# Access Compliance Report

## Public Rights-of-Way

### (Curb Ramps)

Intersection ID: 18086	Main Street: NATIONS_FORD_RD	Cross Street: RADFORD_AV	Location: NW
ADA ID: AF8897F95943	Ramp Type: Directional1	Initial Pass/Fail: Fail	Overall Compliance: No
Severity Score: 13.75			
Codes/Mitigation Info/Possible Solution		Field Measurements/Component Compliance

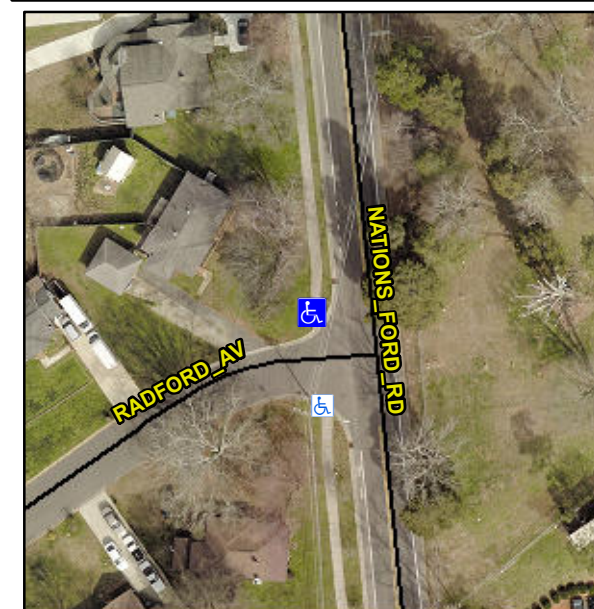
**R304.2.2, R304.5.3**

Compliance	Description	Data	Compliance	Description	Data
N/A	Ramp Length (in)	<b>98.0</b>	N/A	Grade Break?	<b>N/A</b>
Yes	Ramp Width (in)	<b>58.0</b>	N/A	Grade Break Slope (%)	<b>0.0</b>
No	Ramp Slope (%)	<b>8.8</b>	N/A	Grade Break XSlope (%)	<b>0.0</b>
No	Ramp XSlope (%)	<b>3.9</b>			
N/A	Flare Type LT	<b>N/A</b>	N/A	Flare Type RT	<b>N/A</b>
N/A	Flare Slope LT (%)	<b>N/A</b>	N/A	Flare Slope RT (%)	<b>0.0</b>
N/A	Flare Traversable LT?	<b>N/A</b>	N/A	Flare Traversable RT?	<b>N/A</b>
N/A	Landing Length (in)	<b>0.0</b>	N/A	DWS Provided?	<b>N/A</b>
N/A	Landing Width (in)	<b>0.0</b>	N/A	DWS Contrast?	<b>N/A</b>
N/A	Landing Slope (%)	<b>0.0</b>	N/A	DWS Length (in)	<b>N/A</b>
N/A	Landing X Slope (%)	<b>0.0</b>	N/A	DWS Full Width?	<b>N/A</b>
N/A	Landing Curb? (Y/N)	<b>N/A</b>	N/A	DWS Offset LT (in)	<b>N/A</b>
N/A	Shared Landing?	<b>N/A</b>	N/A	DWS Offset RT (in)	<b>N/A</b>
N/A	Gutter Ponding?	<b>0.0</b>	N/A	Gutter Slope (%)	<b>N/A</b>

N/A	Gutter Lip Ht (in)	<b>0.0</b>	N/A	Gutter X Slope (%)	<b>N/A</b>
N/A	Painted X Walk1?	<b>No</b>		Road Slope (%)	<b>0.1</b>
	X Walk 1 Direction	<b>To SE</b>		Road X Slope (%)	<b>3.8</b>
	X Walk 1 Width (in)	<b>N/A</b>		Clear Space?	<b>N/A</b>
	X Walk 1 Slope (%)	<b>0.1</b>	N/A	Clear Space to XWalk (in)	<b>N/A</b>
	X Walk 1 X Slope (%)	<b>3.8</b>	N/A	Storm Grate/Utility Hazard?	<b>N/A</b>
N/A	Ramp inside XWalk1?	<b>N/A</b>		Storm Grate/Utility Type	
N/A	Any Obstructions?	<b>N/A</b>			<b>N/A</b>
	Obstruction Type		Yes	Surface Condition? (G/P)	<b>Good</b>
			N/A	Curb Slope (%)	<b>10.0</b>

**Remove & Replace Entire Ramp.**
